# BYLONG COAL PROJECT

Environmental Impact Statement  
Supplementary Response to Submissions  
August 2016

Response to  
Department of Primary  
Industries - Water  
Submission

**Bylong Coal Project  
Response to Department of Primary Industries – Water Submission, Dated 12 May  
2016**

**Figure 7-7 Head differentials between MS and USG for Layer 2 for Null Conditions (at the End of the Mining Period)**

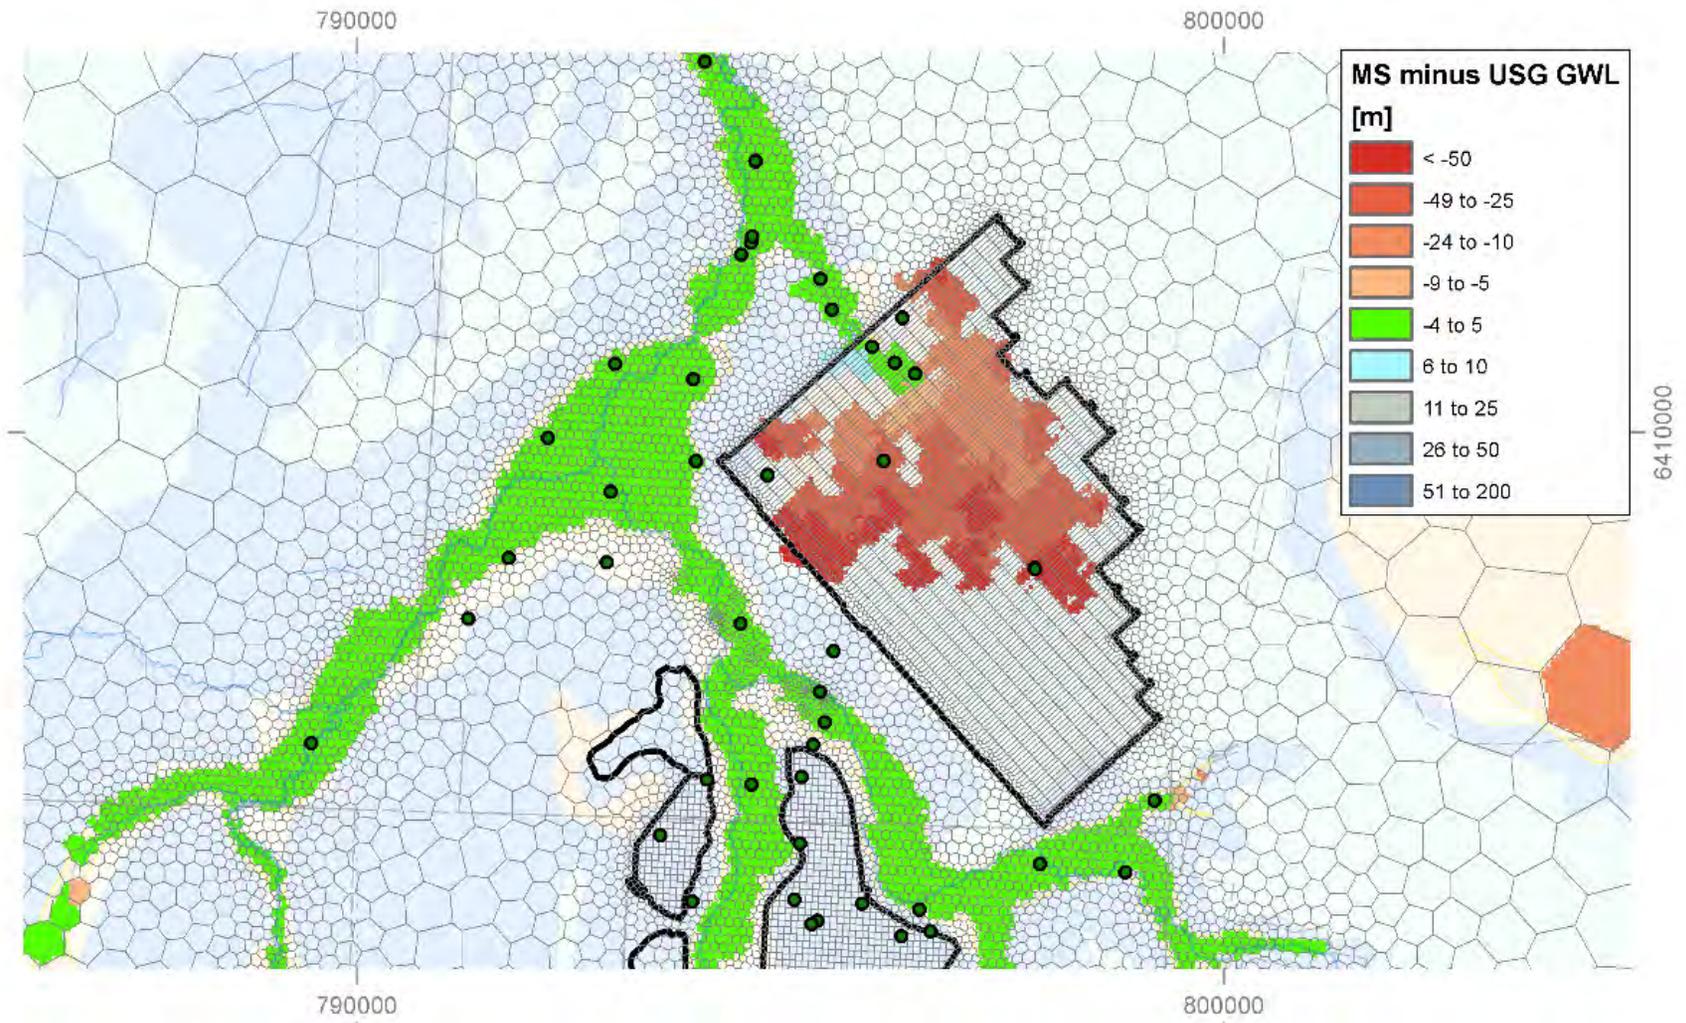
HS has carried out a brief analysis of the supplied head distributions to reveal the spatial head differentials on the water table (in Layer 2) at the end of the simulation period, as shown in **Figure 7-7**.

**Figure 7-7** shows that modelled water levels are very similar, typically within less than a metre, through the alluvium (green areas on **Figure 7-7**). There are, however, significant differences in the modelled heads in the basalt areas, which are more likely to exist as a perched aquifer and possibly switching between saturated and unsaturated through time (whereas the alluvium is likely to be saturated more consistently). The differences observed between the two sets of modelled heads are up to about 50 m (orange-red areas on **Figure 7-7**), with the MS model simulating heads below those of the USG model.

Figure 7-8 Simulated Baseflow for Null Conditions

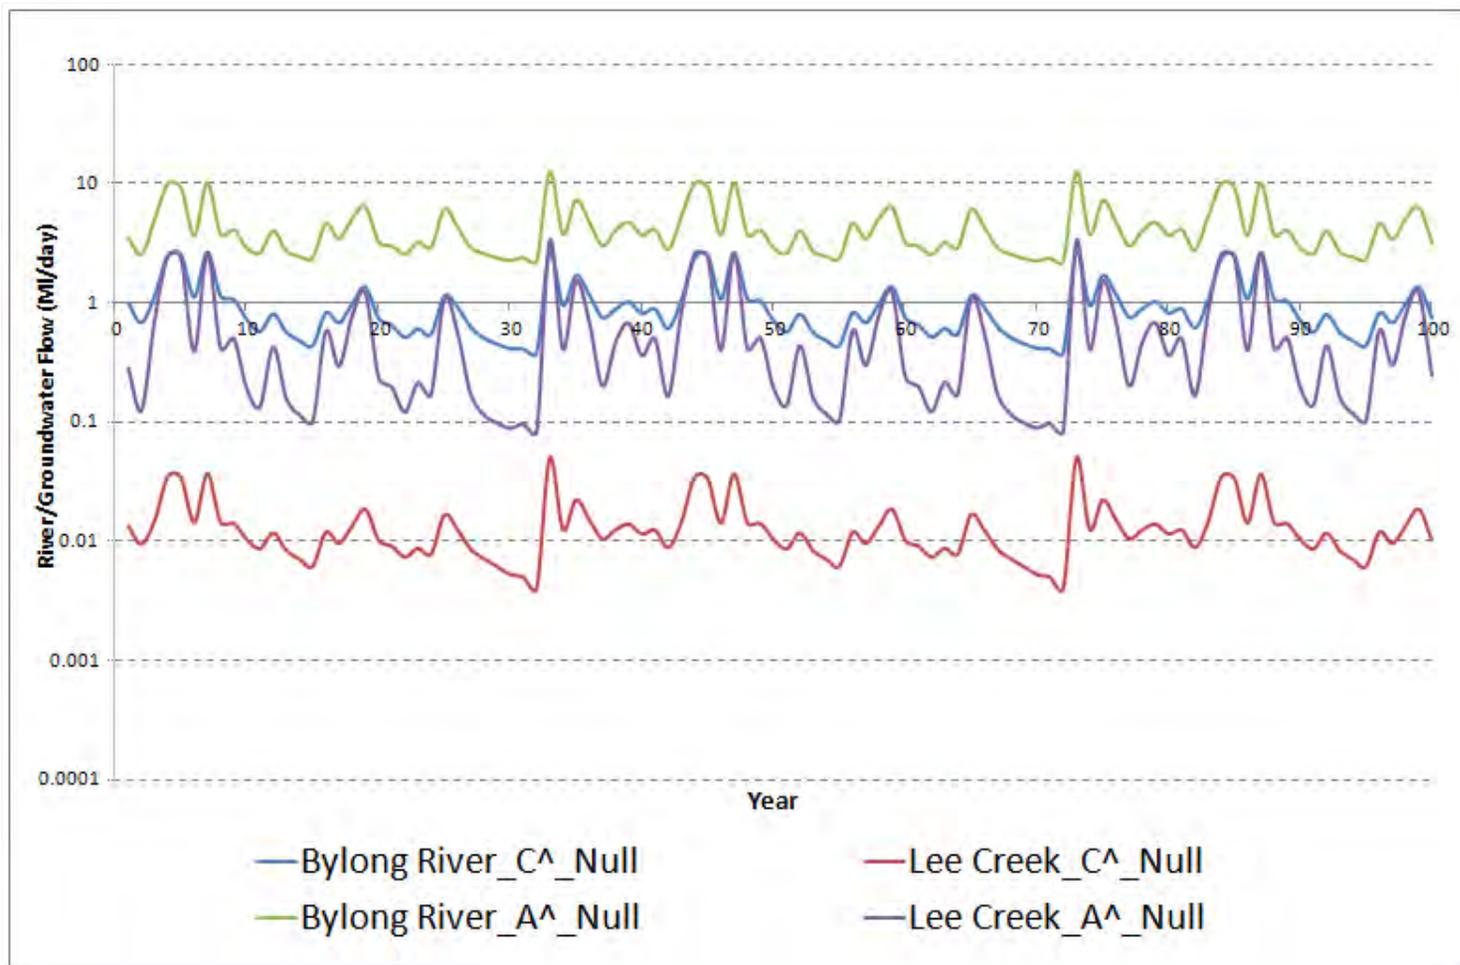
AGE also provided a time-series plot of simulated baseflows for the Bylong River and Lee Creek, as shown in **Figure 7-8**, while the whole-of-model water balance for the two null runs is shown in **Table 7-1**.

The pseudo-soil simulation reports much less baseflow (**Figure 7-8**), generally by 70% of an order of magnitude at Bylong River and by 1-2 orders of magnitude at Lee Creek. This is consistent with the water balance (**Table 7-1**), which shows very different magnitudes for evapotranspiration and river leakage and baseflow. For MS, the ET is 28% of the total outflow whereas for USG it is 95%. Conversely, the baseflow is 72% of the total outflow for MS whereas for USG it is only 5%.

Figure 7-12 Drawdown Differentials between MS and USG for Layer 2 for Mining Conditions

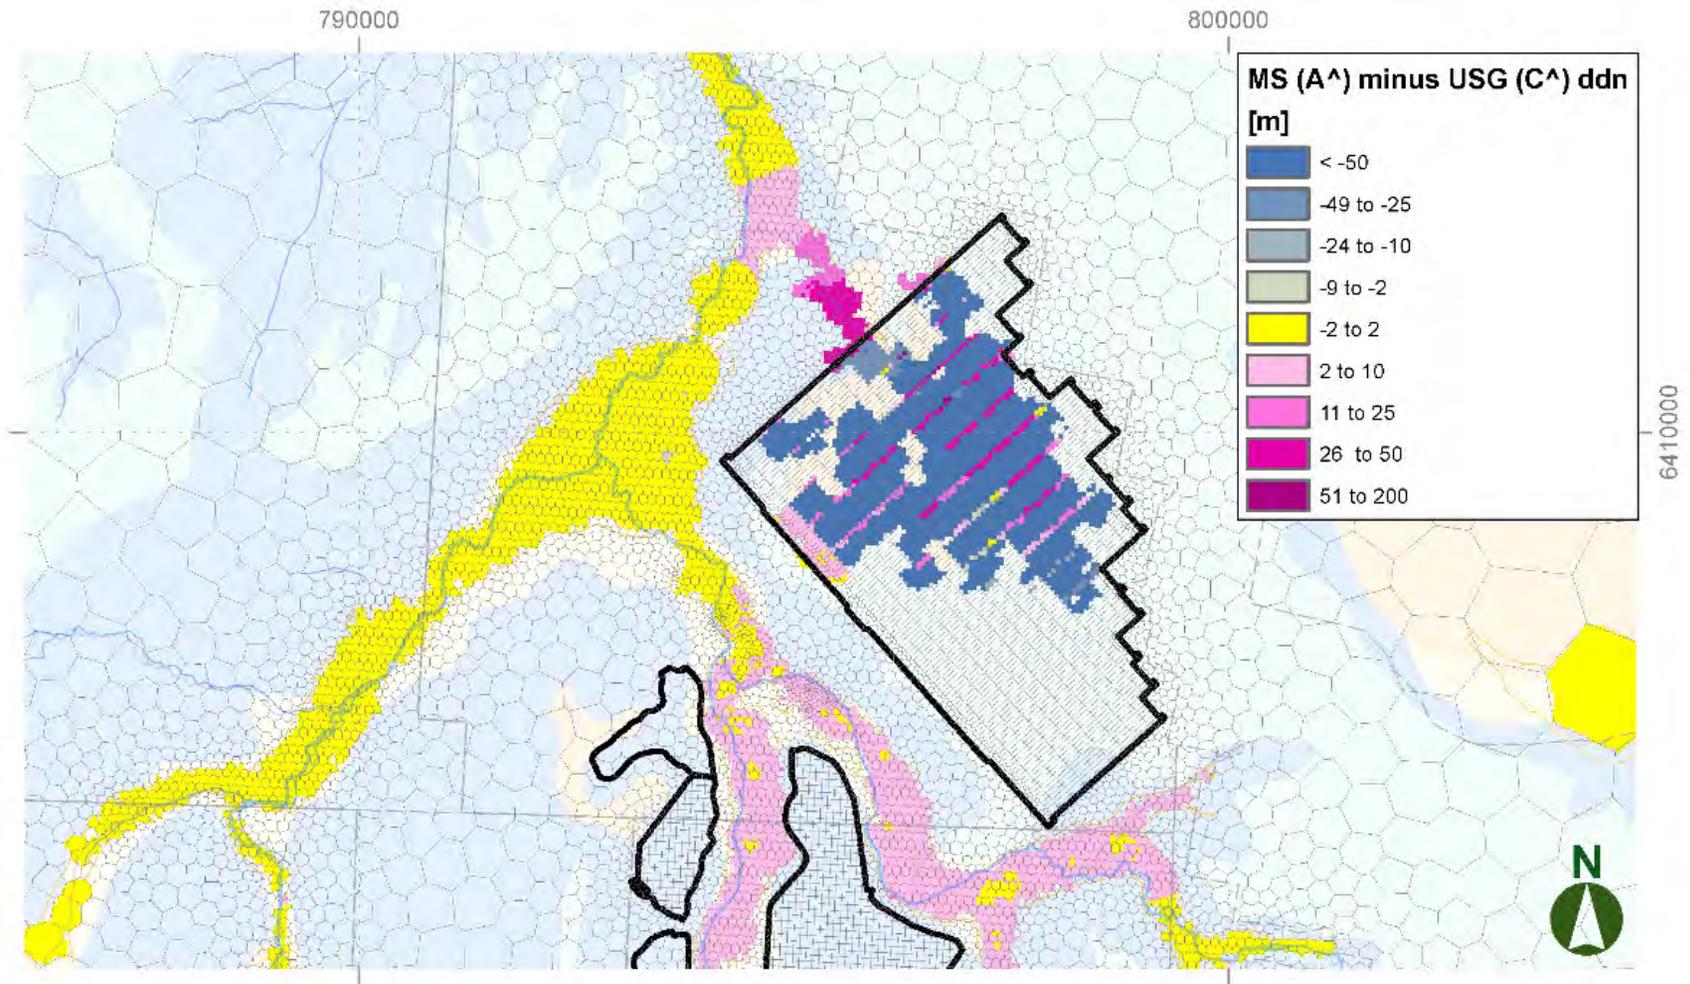
A comparison of the predicted groundwater drawdown (water table) from the mining-affected scenario of models A<sup>^</sup> and C<sup>^</sup> is presented as **Figure 7-12**.

**Figure 7-12** shows that the drawdown predicted by the two models is relatively similar across much of the alluvium (yellow), but A<sup>^</sup> (MS\_vadose) drawdown is typically greater than C<sup>^</sup> (USG\_pseudo) drawdown in those yellow areas as well as the pink areas in the alluvium.

However, above the longwall area the drawdown predicted by C<sup>^</sup> is considerably greater than that predicted by A<sup>^</sup> (dark blue areas on **Figure 7-12**), with the exception of the cells immediately overlying the pillars (pink/purple stripes). The key is that the pseudo-soil or upstream weighting setting (as in C<sup>^</sup>) switches horizontal transmissivity to zero when a cell becomes fully unsaturated, while the vadose zone representation of A<sup>^</sup> maintains some horizontal connection (while vertical connection is maintained in both cases)<sup>4</sup>.

Figure 7-13 Simulated Baseflow Impacts for Mining Conditions

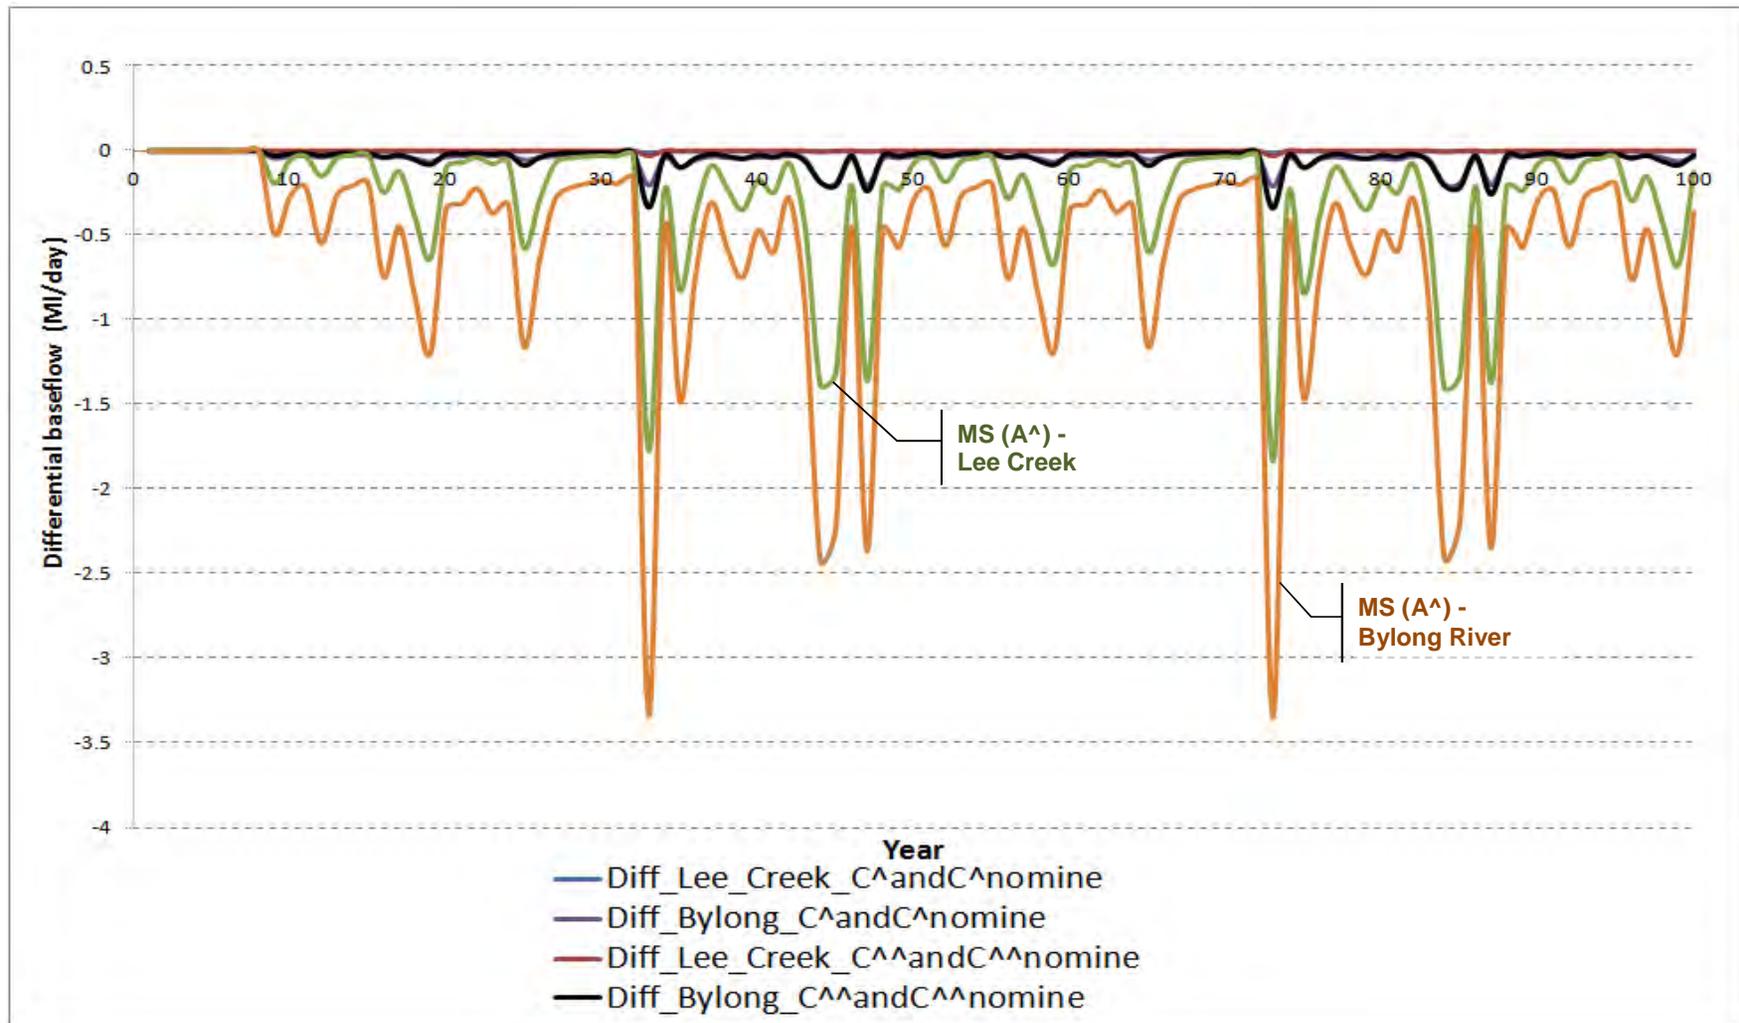
AGE also provided a time-series plot of simulated baseflow impacts for Bylong River and Lee Creek, shown in **Figure 7-13**<sup>5</sup>. The baseflow impacts reported by MS are much greater than reported by USG, by more than one order of magnitude.

The baseflow impacts for this comparison are included on **Figure 7-13**, where it is seen that conversion of USG from pseudo-soil to vadose properties results in an approximate doubling of the baseflow impact. However, it is still about one order of magnitude less than that reported by MS for the same vadose properties.
